**Re: Addendum No. 4**  
**City of Canton Water Reclamation Facility**  
**Phosphorus/Total Nitrogen Project Contract No. 26**

Date: January 2, 2014

ADD 4 5-02  
 119 OF 375

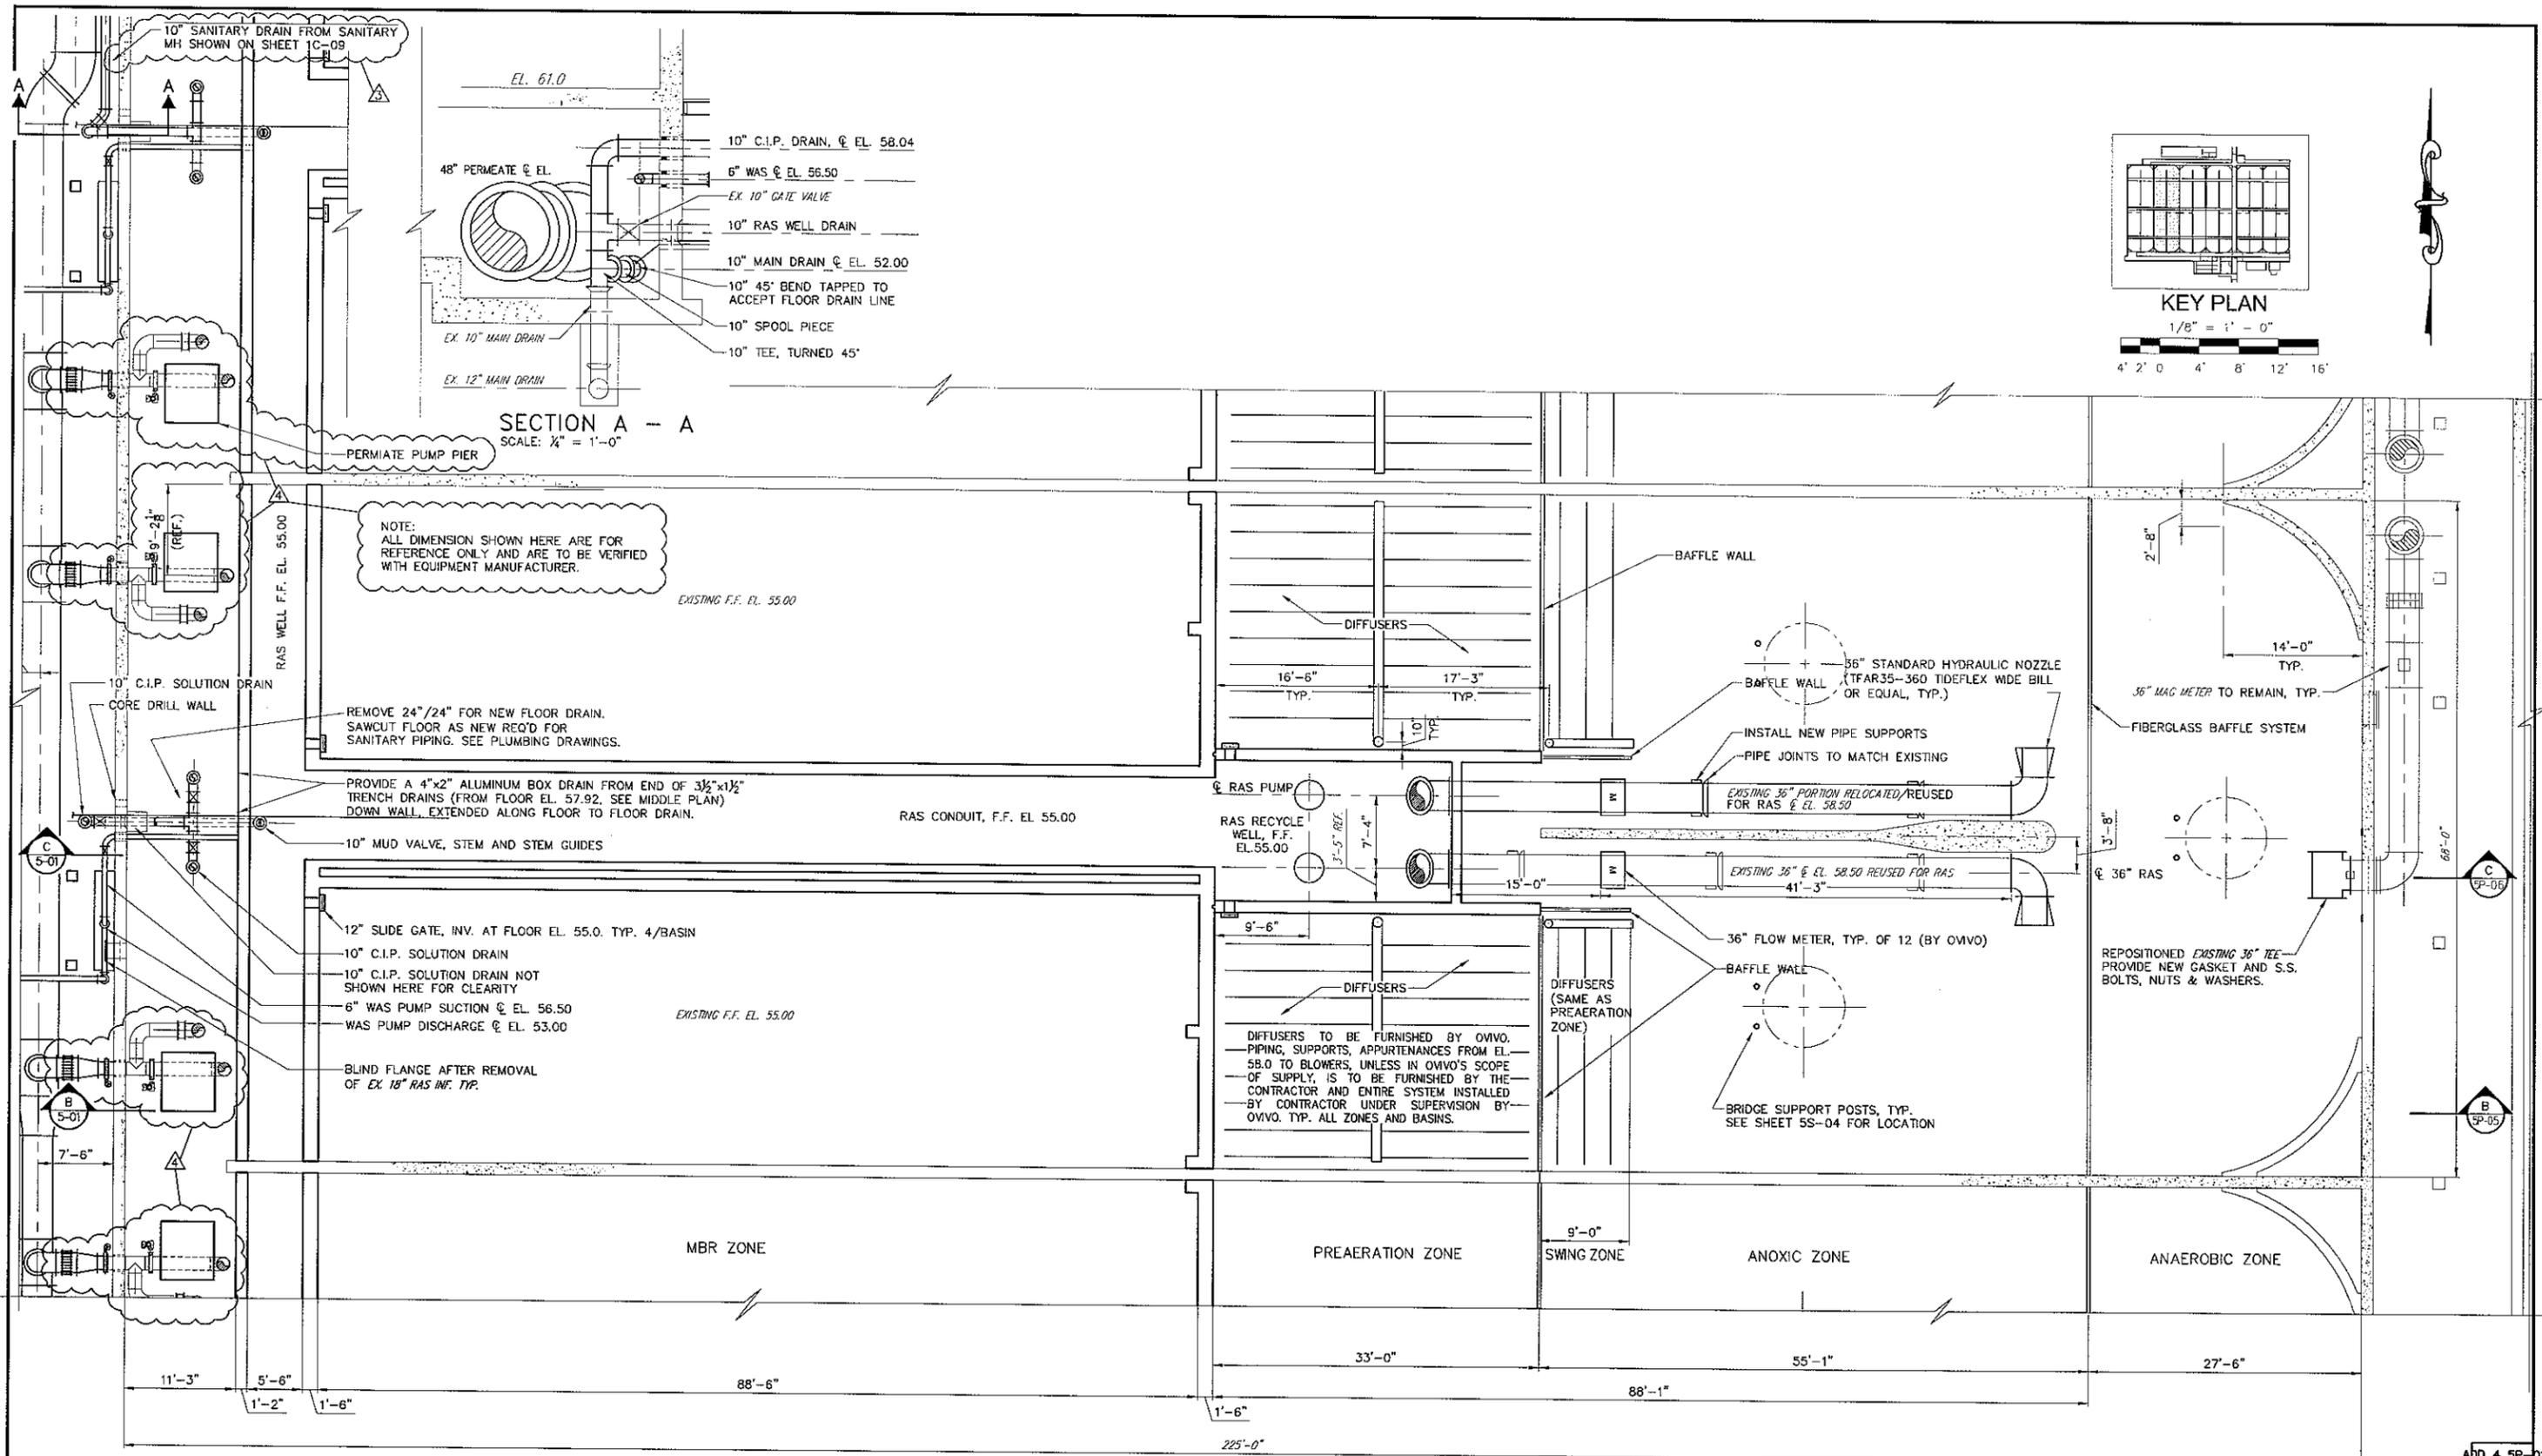
- Sheet 118 5-01 **REVISE** Permeate Piping Layout, **ADD** Pump Piers.  
Sheet 119 5-02 **REVISE** Permeate Piping Layout, **ADD** Pump Piers.  
Sheet 135 5P-01 **REVISE** Permeate Piping Layout, **ADD** Pump Piers.  
Sheet 136 5P-02 **REVISE** Permeate Piping Layout, **ADD** Pump Piers.  
Sheet 141 5P-07 **REVISE** Permeate Piping Layout, **ADD** Pump Piers.  
Sheet 142 5P-08 **REVISE** Permeate Piping Layout, **ADD** Pump Piers.  
Sheet 208 10D-06 **REMOVE** and **REPLACE** Sheet.  
Sheet 209 10D-07 **REMOVE** and **REPLACE** Sheet.  
Sheet 210 10D-08 **REMOVE** and **REPLACE** Sheet.  
Sheet 217 10S-04 **REMOVE** and **REPLACE** Sheet.  
Sheet 218 10S-05 **REMOVE** and **REPLACE** Sheet.

NO.	REVISION DATA	DATE	BY	APP'D
1	REVISED PERMEATE PIPING LAYOUT, ADD PUMP PIERS	12/13	RLM	CWJ
